Town of Breckenridge
Planning Commission Agenda

Tuesday, August 3, 2010
Breckenridge Council Chambers
150 Ski Hill Road

Planning Commission Staff Report

Planning Commission Staff Report

① Garage Floor
1/8" = 1'-0"

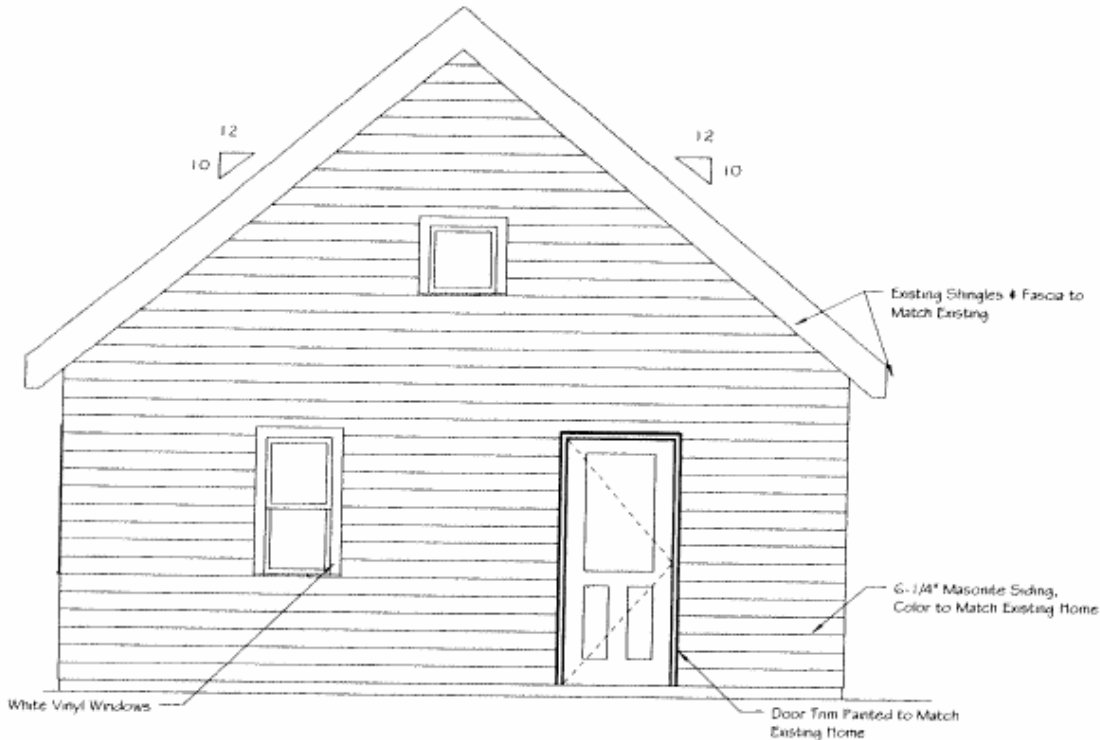
Site Plan: The proposed garage meets all the required setbacks of the Wellington Neighborhood Master Plan. Vehicular and garage access is proposed from the private alley at the rear of the residence. Site drainage is adequate. Staff supports the proposed site plan.

North Elevation
3/16" = 1'-0"

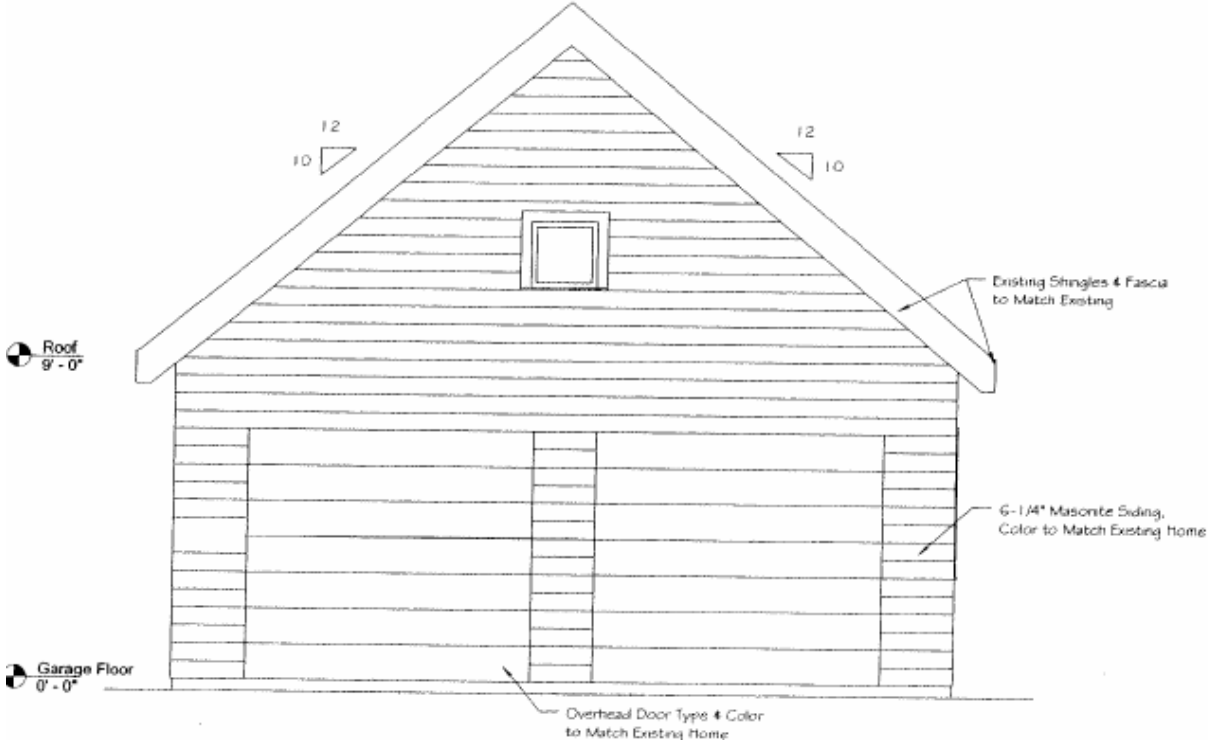
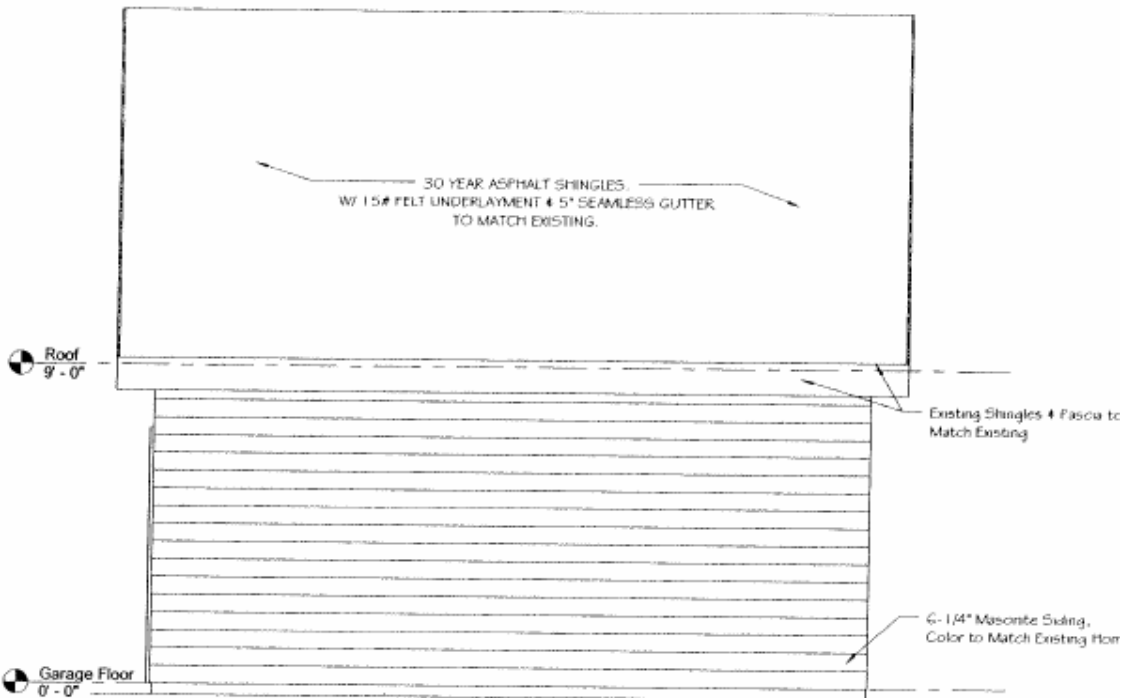
Architecture: The proposed design of the garage uses simple lines and traditional form, based on the Wellington Neighborhood Master Plan. The primary exterior materials will match the existing home, and have been previously described.

North Elevation
Scale: 1/4" = 1'-0"

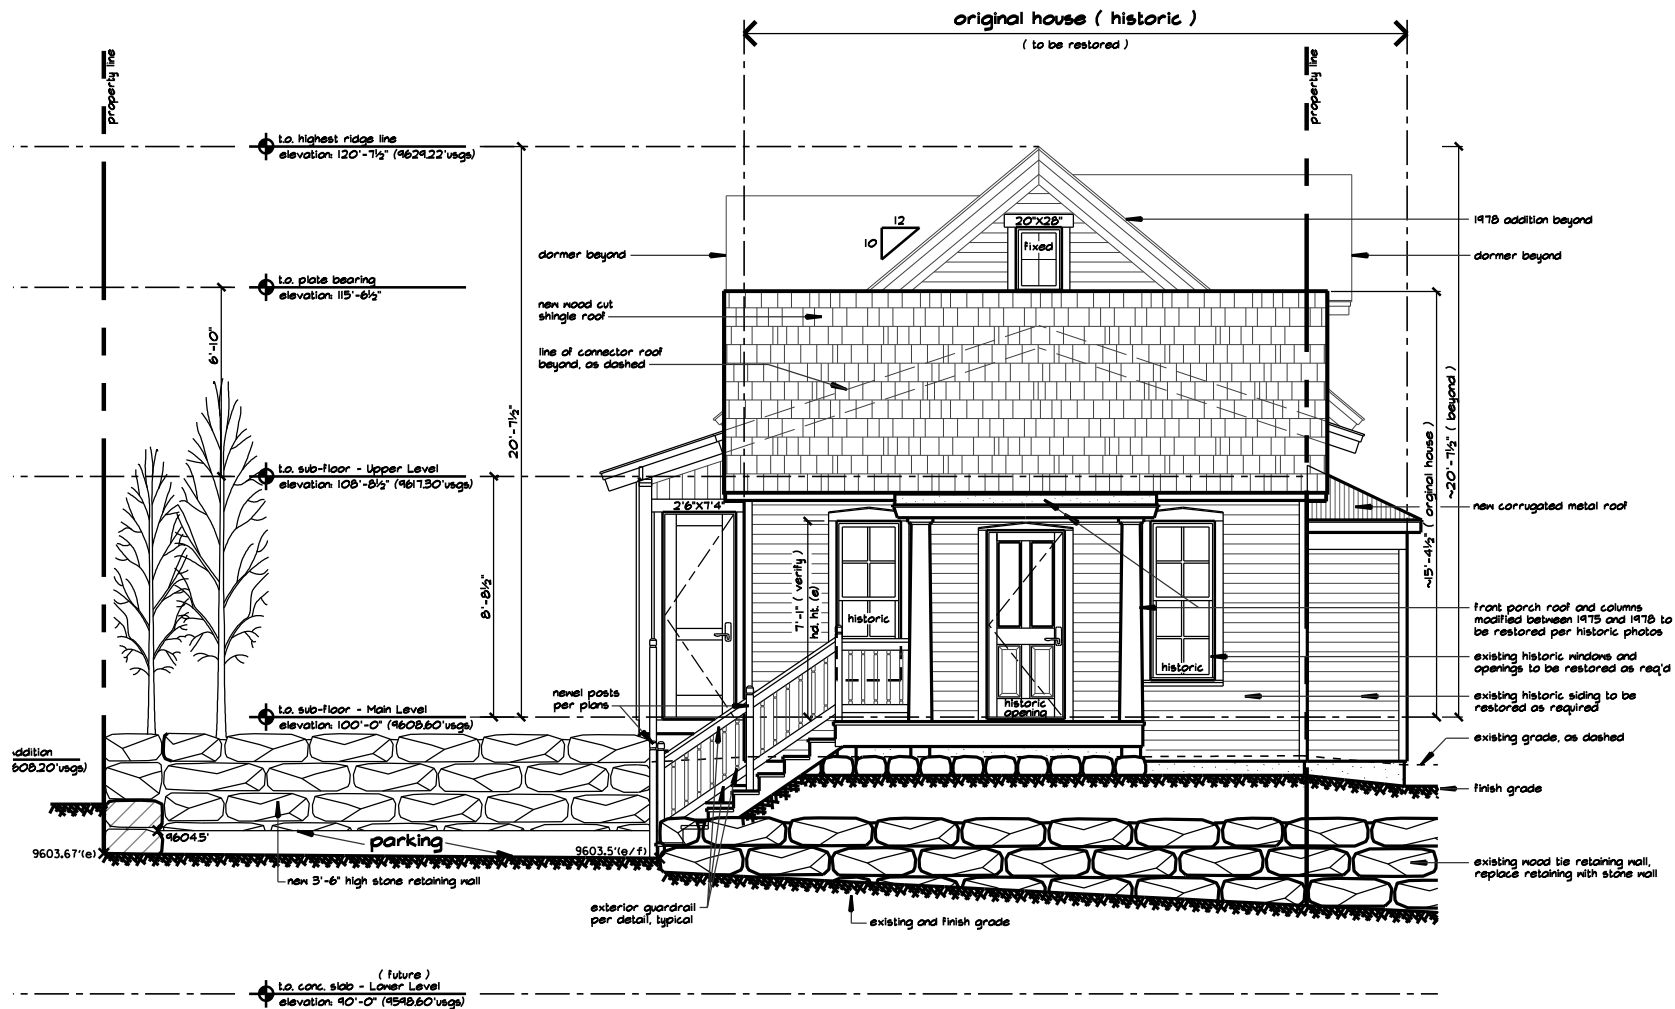
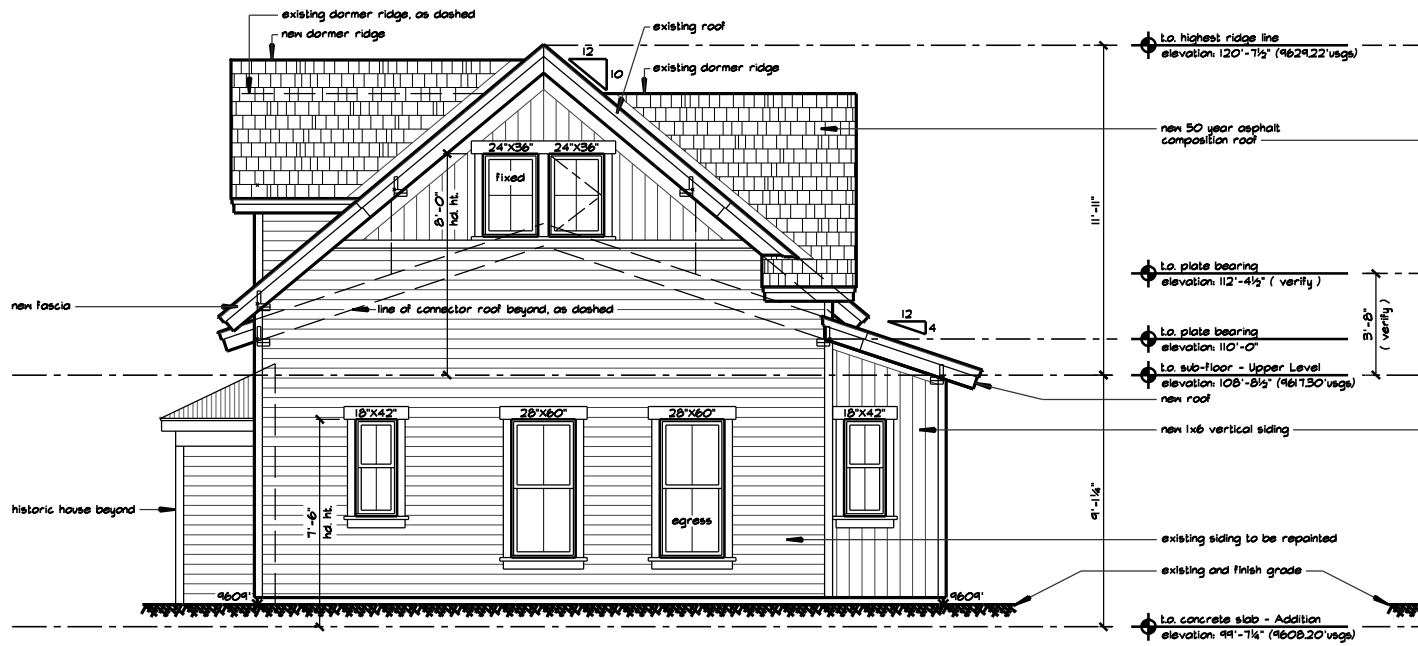
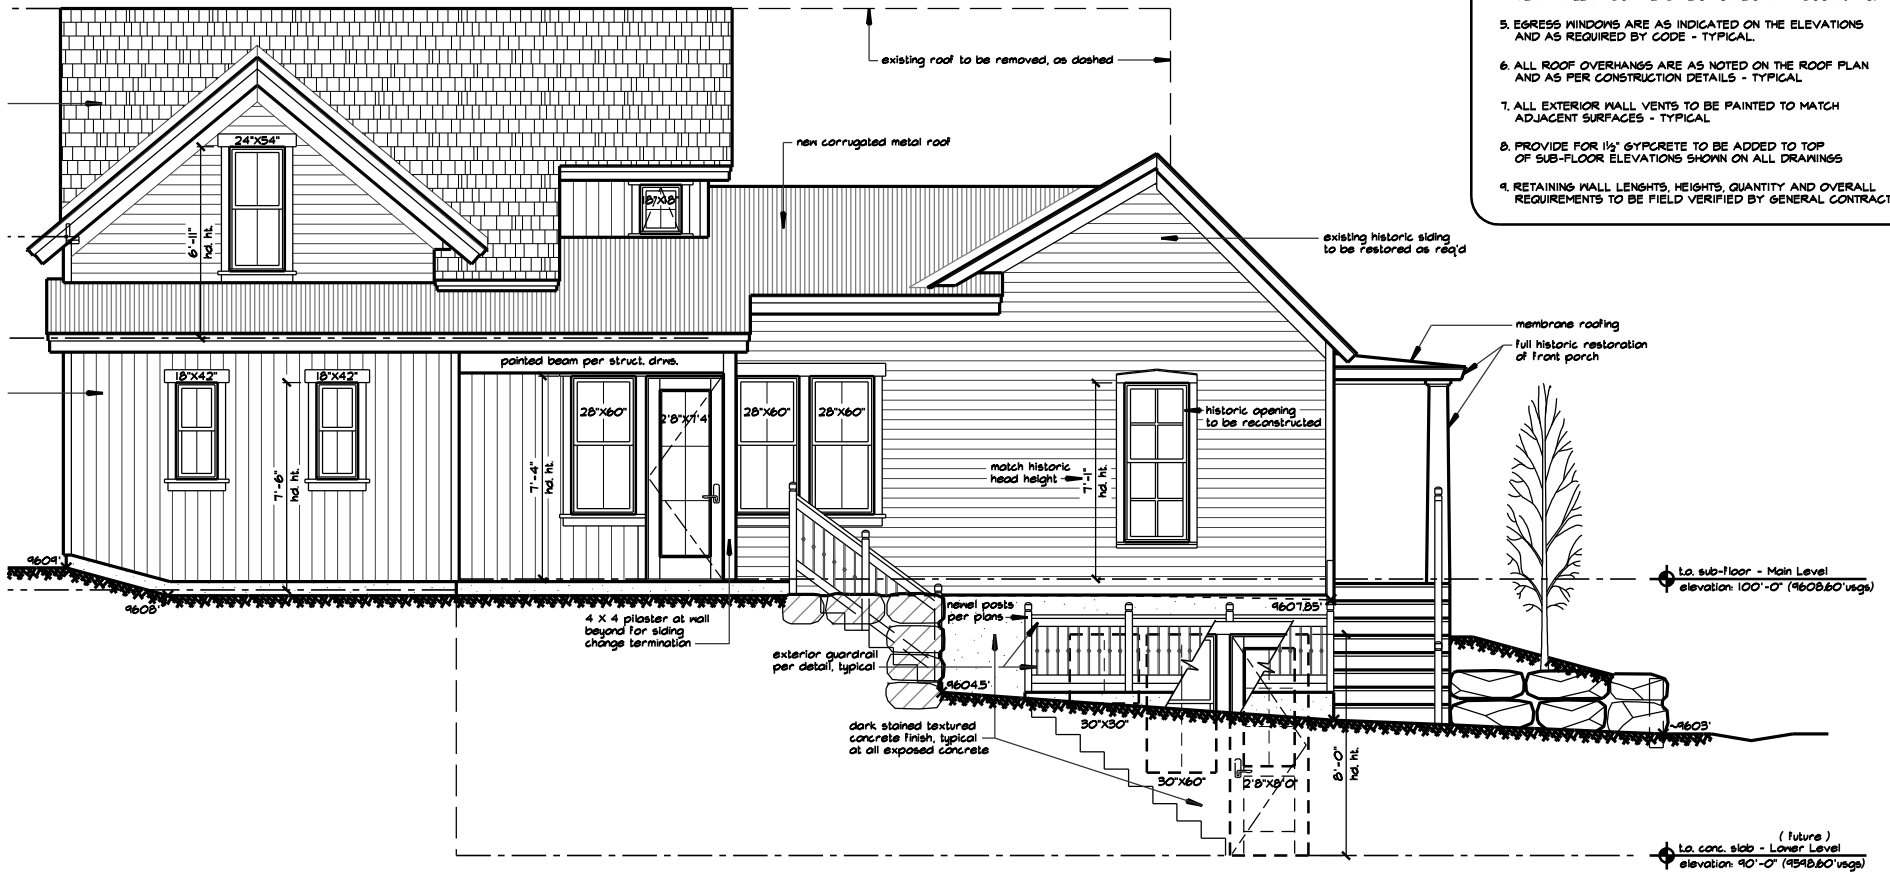
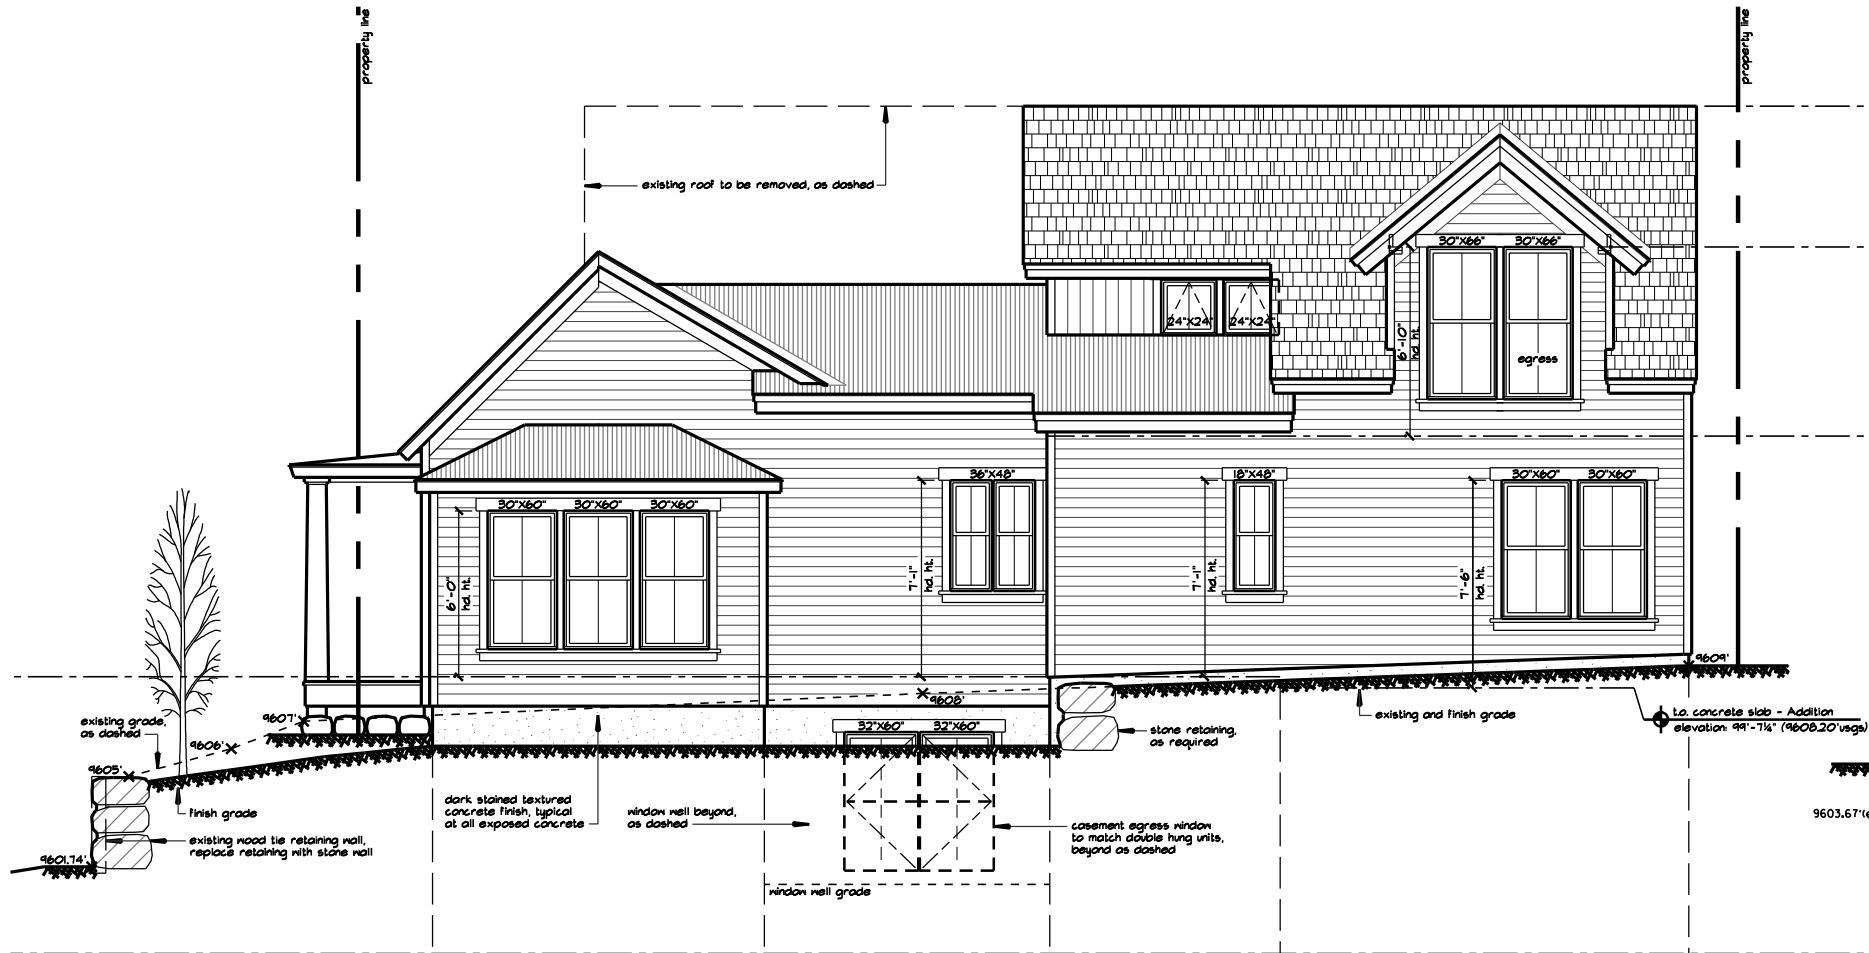
The planned improvements include:

1. Remove the north facing roof “growth” over historic main ridge of the historic house, cut the roof addition back approximately 12 to 14 feet and lower this ridge below the original historic ridge to better create the appearance of a "connector", as defined in the Historic Standards.

2. The existing density under this roofed area will be removed (currently a bedroom).
3. Remove the east and west non-historic bay windows (keeping the west facing historic bay window) on the historic structure, per plan (19 sq. ft.)

4. Restore the original roof form to the greatest degree possible on the historic structure.
5. Restore all original window openings and replace the front (north) door with a historically compliant door.

6. Full restoration of the front porch with correct post detailing (existing posts to be replaced based on photographs).
7. After locally Landmarking, add full basement under historic footprint (zero lot line on west).

8. On the non-historic addition, correct all windows to historically compliant vertically orientated double hung windows.
9. Correct roof form in non-compliant addition.

Basement Plan

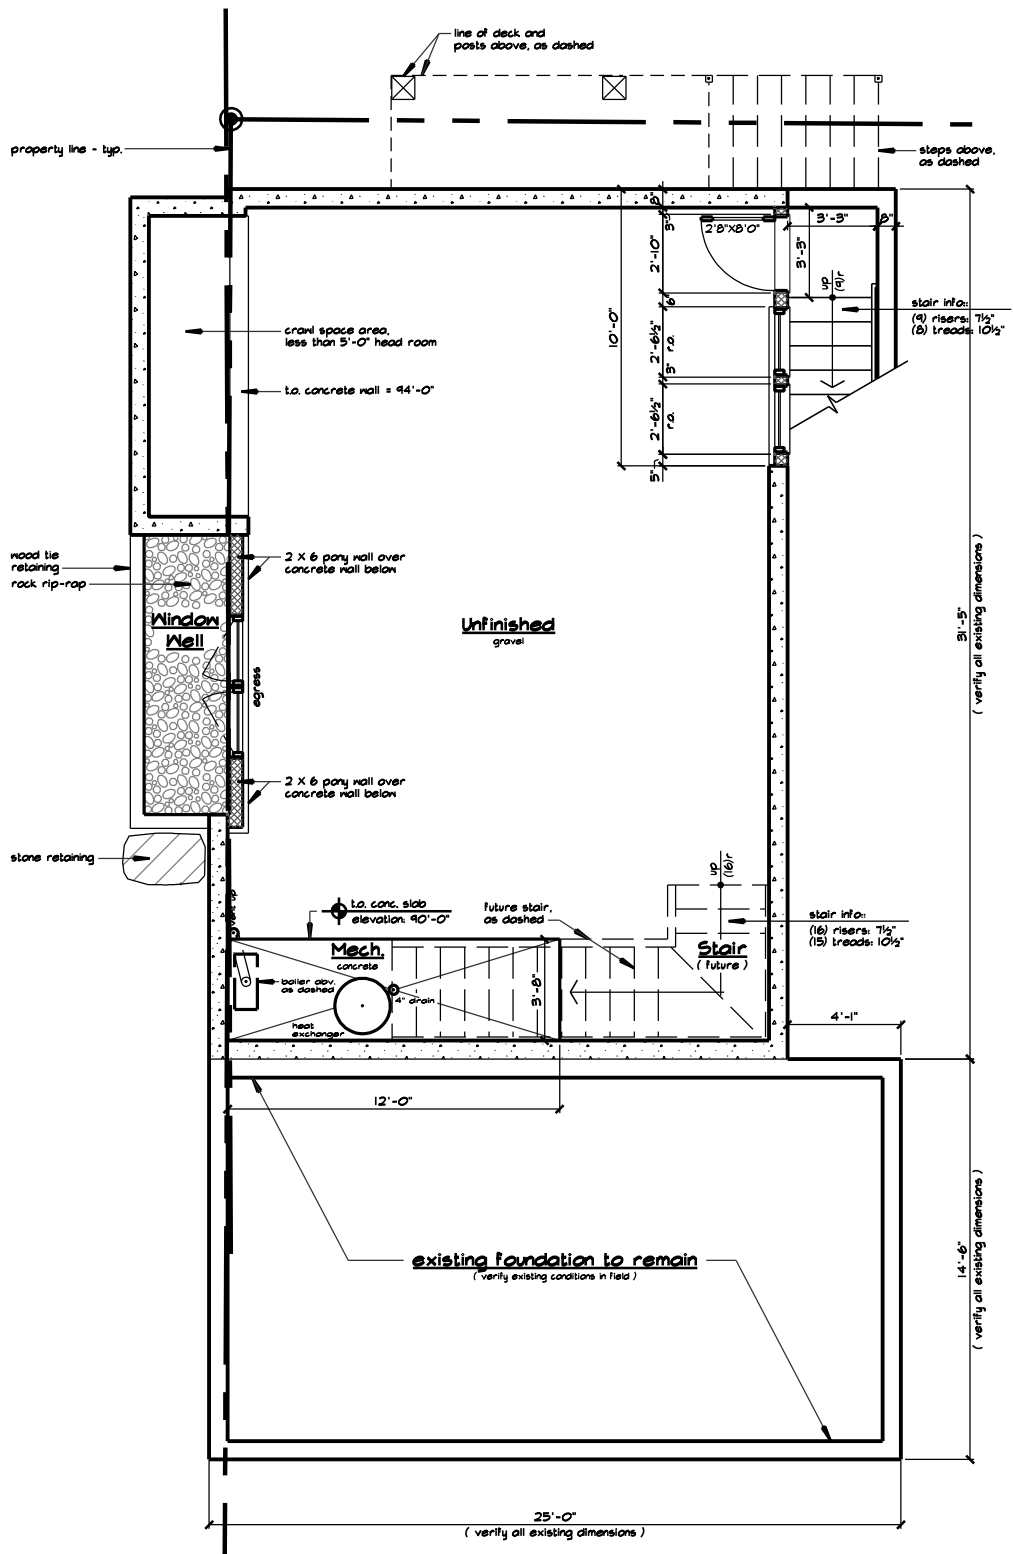
Land Use (Policies 2/A & 2/R): The proposal conforms to the suggested uses for this Land use District. As discussed at the last hearing, the possibility of the basement being converted to a bandit Accessory apartment based on the proposed external access was not a concern to four of the six Planning Commission members. Staff has no concerns.

As part of this application, the applicant is seeking a local landmark designation which would allow a basement beneath the historic house without adding density calculations under this policy. We have added a Condition of Approval that, prior to issuance of a building permit, the Applicant shall obtain approval of an ordinance from the Breckenridge Town Council for local landmark status for the property.
